Riverview House, Uxbridge

Class 0 Change of Use Application

Project Title:	Riverview House, Uxbridge
Project Ref:	1153
Report Title:	Class 0 Change of Use Application
Report Ref:	P931
Revision:	0
Date of Issue:	September 2022
Purpose of Issue:	Information
Compiled By:	Beatriz Antuna Tentor
Reviewed By:	Ben Paterson
Review Date:	12-09-22
File Location:	-

Proposed Amended Plan REF: 1153-P130-0 GA PROPOSED GROUND FLOOR PLAN

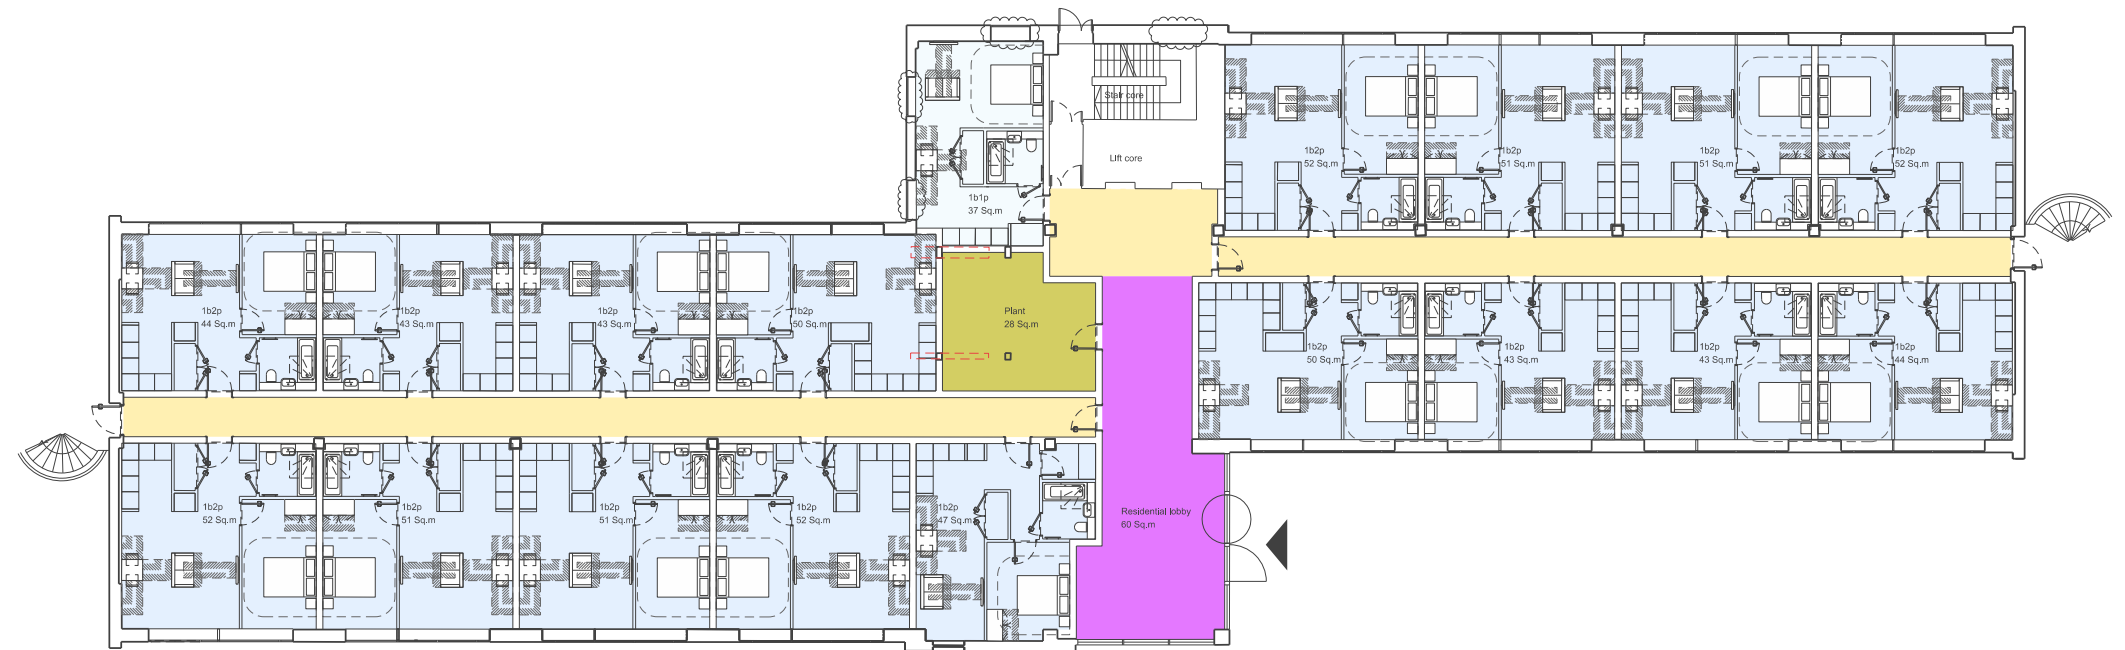
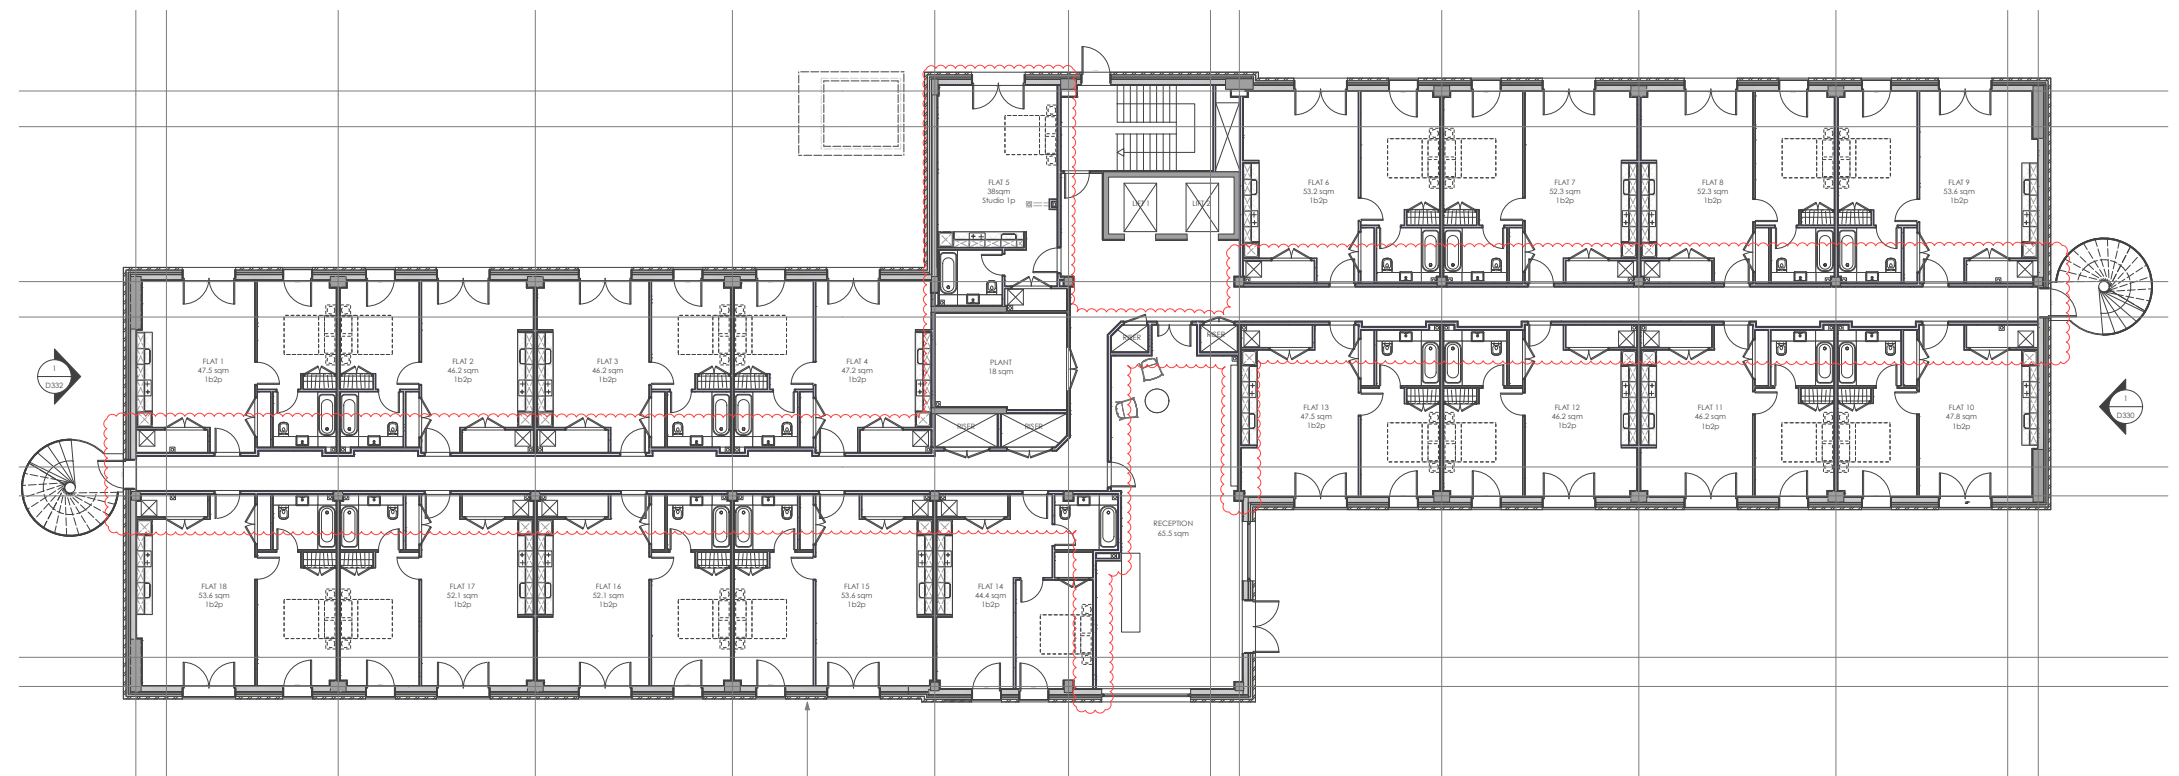
- The arrangement of apartments on the ground, floors, is consistent with the consented scheme where the predominant changes occur along the internal wall of apartments where the width of the corridor has narrowed slightly to allow for generally 1200mm clear wall-to-wall, with passing spaces 1500mm in width. The naming conventions of the individual apartments is consistent with the NDSS and the previous application.

- Minor rationalisation of the ground floor reception and 1b2p apartment adjacent where the size and location of the existing structure is now better understood following strip out of the existing building.

- Minor internal modifications of apartments to create improved, more open plan living accommodation, with better access to storage.
- Rationalised arrangement of bathrooms and coordination of services between the ground and fourth floors.

- Modification of Apartment 5 (left-hand side of the stair core) owing to the position of the existing primary structural fin walls which cannot be removed.

- To the north and east elevations, where windows were previously not identified on plan these are now captured.
- Revised riser positions and sizes following MEP advice.

Proposed Amended Plan REF: 1153-P131/2-0_GA PROPOSED FIRST FLOOR PLAN

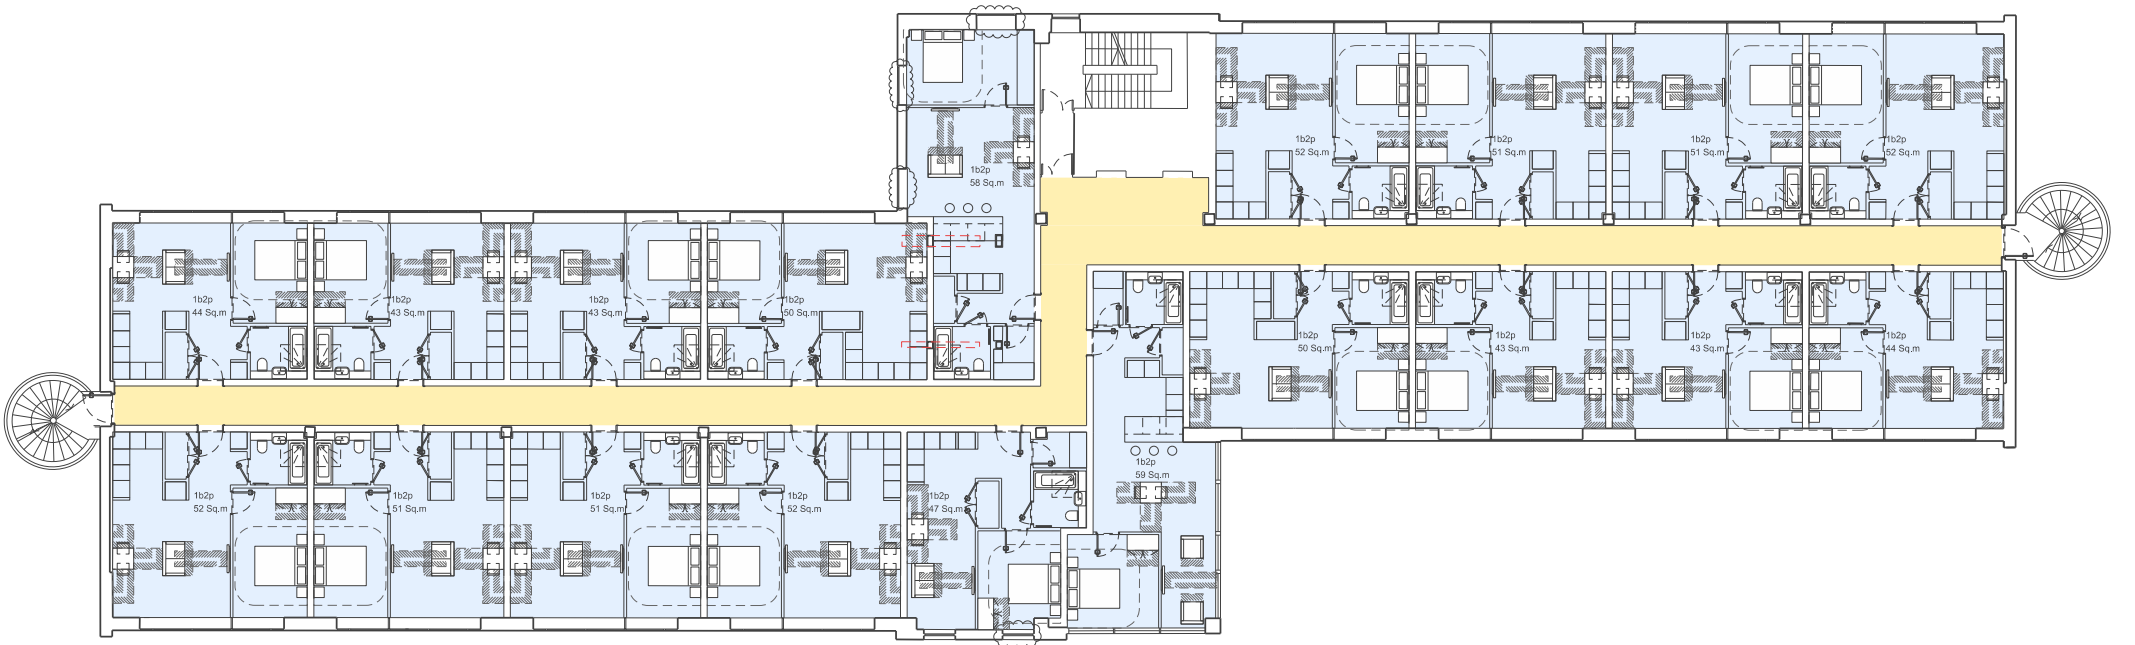
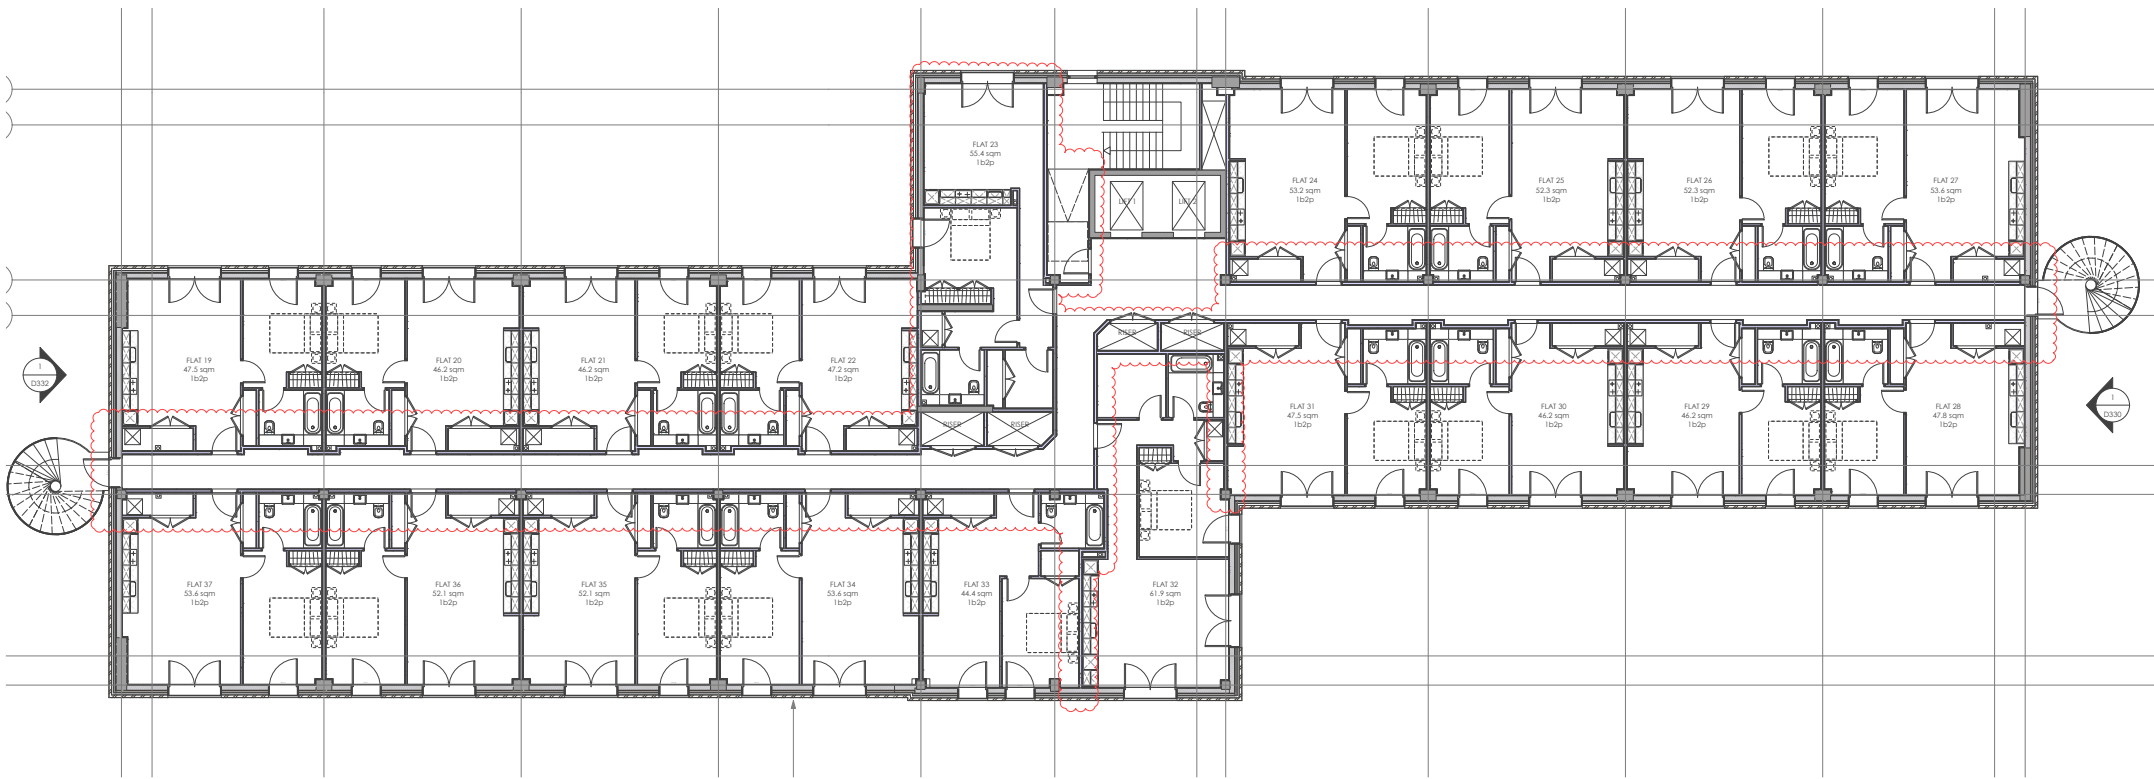
- The arrangement of apartments on the first and second floors are consistent with the consented scheme where the predominant changes occur along the internal wall of apartments where the width of the corridor has narrowed slightly to allow for generally 1200mm clear wall-to-wall, with passing spaces 1500mm in width. The naming conventions of the individual apartments is consistent with the NDSS and the previous application.

- Inclusion of a localised ramp adjacent to the lift core and between the stair landing and the lift lobby. The ramp allows for level differences between the slab and stair landing.

- Minor internal modifications of apartments to create improved, more open plan living accommodation, with better access to storage.
- Rationalised arrangement of bathrooms and coordination of services between the ground and fourth floors.

- Modification of Apartment 23/42 (left-hand side of the stair core) owing to the position of the existing primary structural fin walls which cannot be removed.

- To the north and east elevations, where windows where previously not identified on plan these are now captured.
- Inclusion of risers where these were previously missed of the arrangement plan.

- Modification of the internal layout of apartment 32/51, following changes to the arrangement of the service risers.

Proposed Amended Roof Plan REF: 1153-P136-0_GA PROPOSED ROOF PLAN

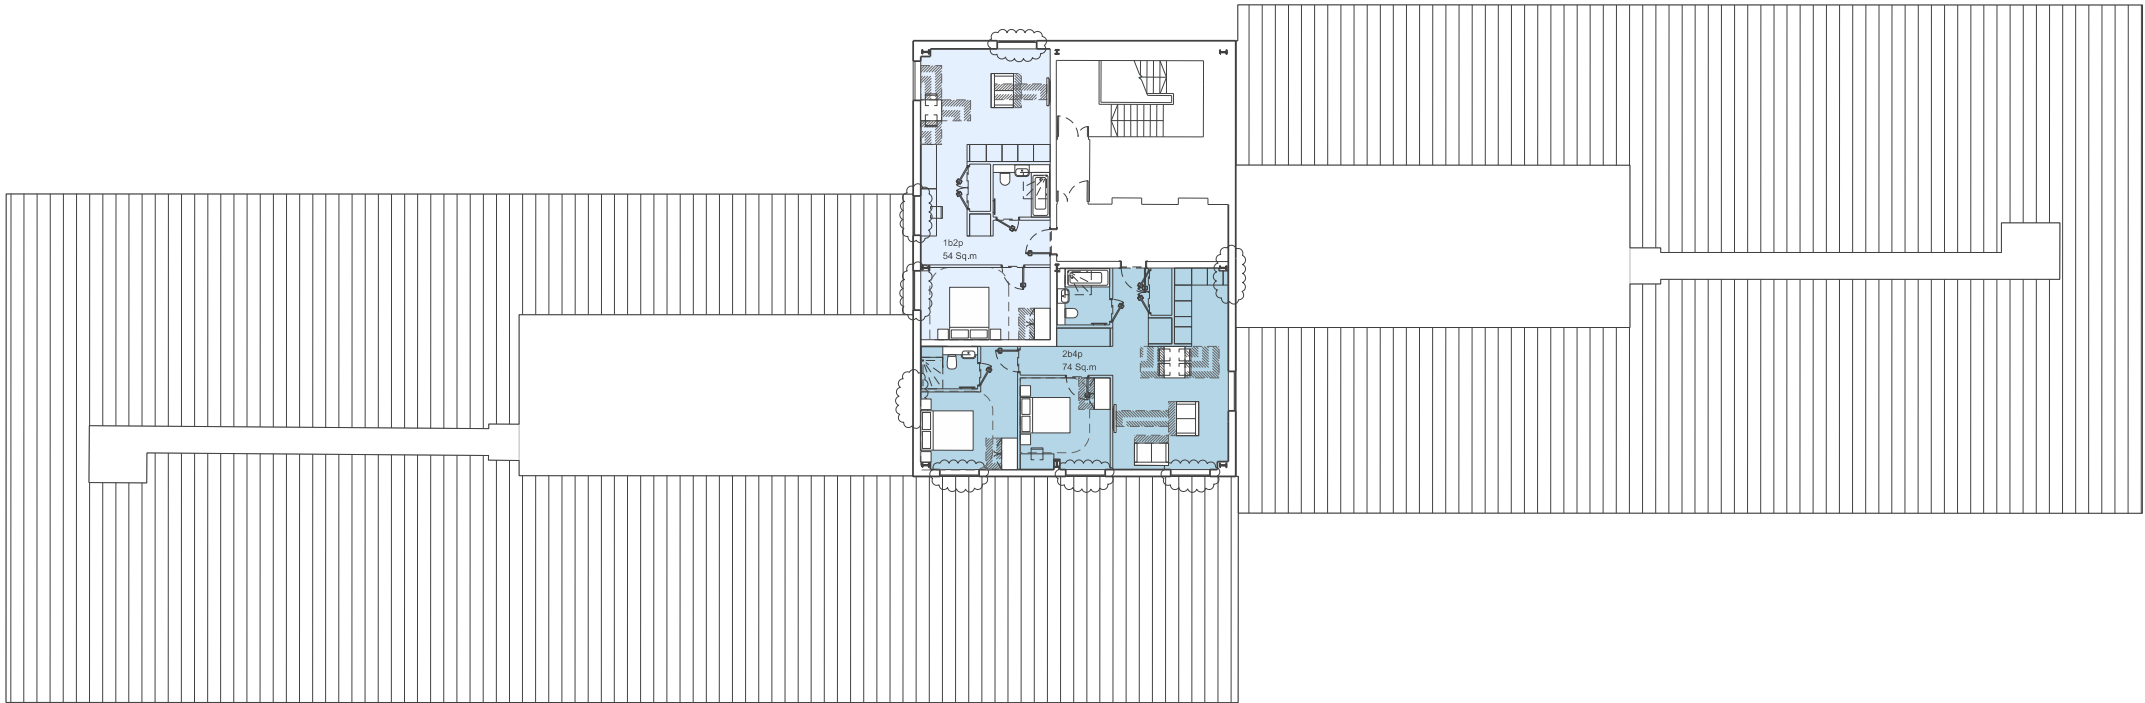
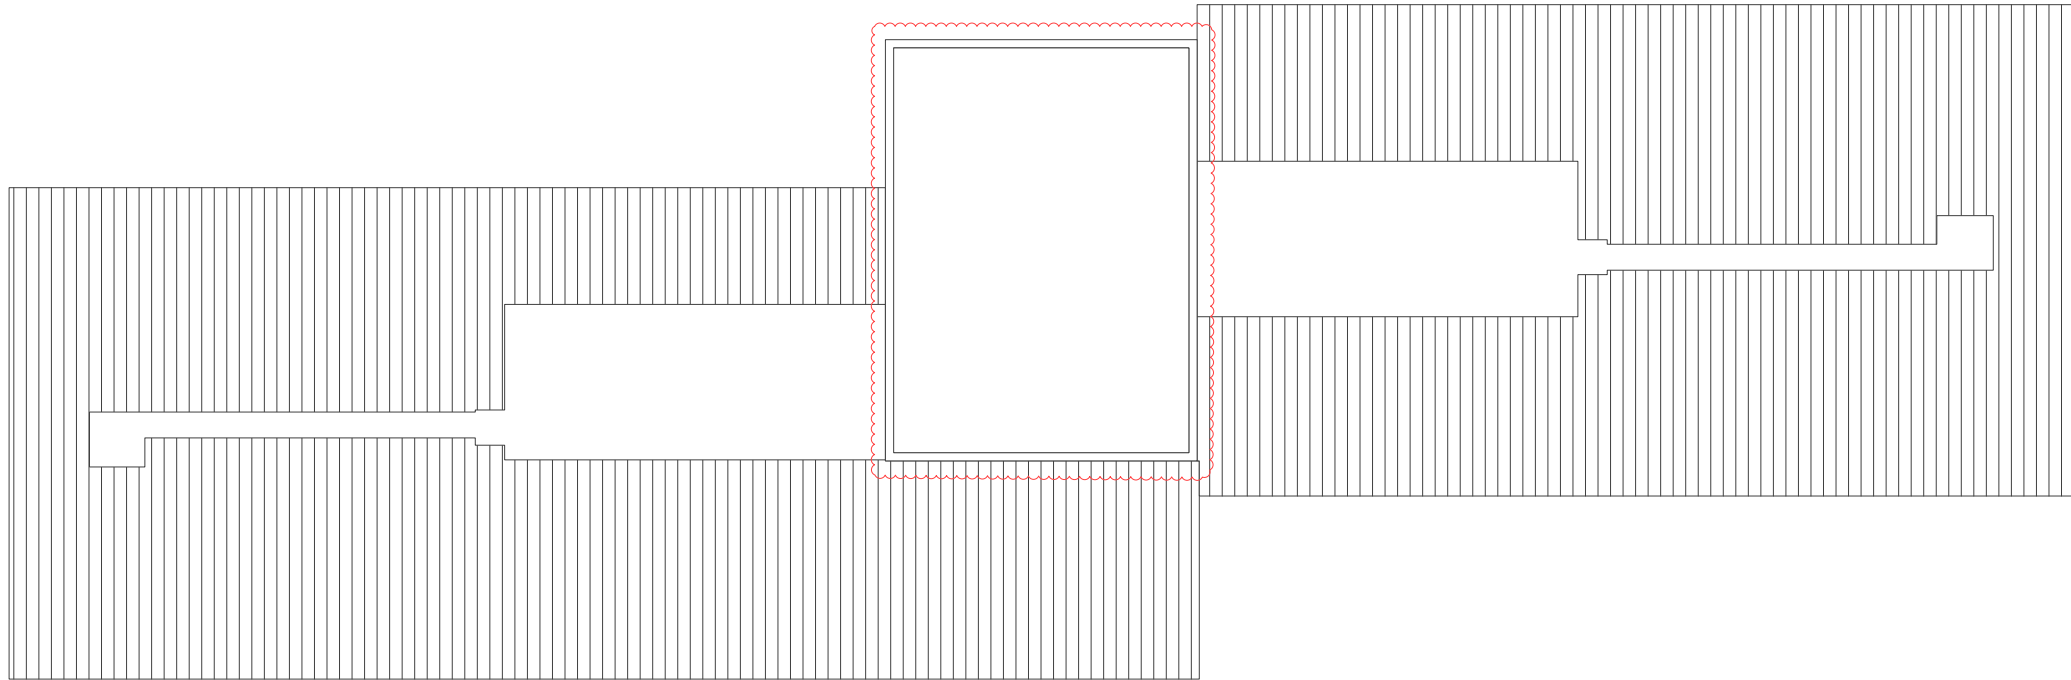
- As a result of a further application in which the addition of two stories have been approved, the adjacent two flats have been made redundant. Therefore, this amendment aims to omit these within its related application.
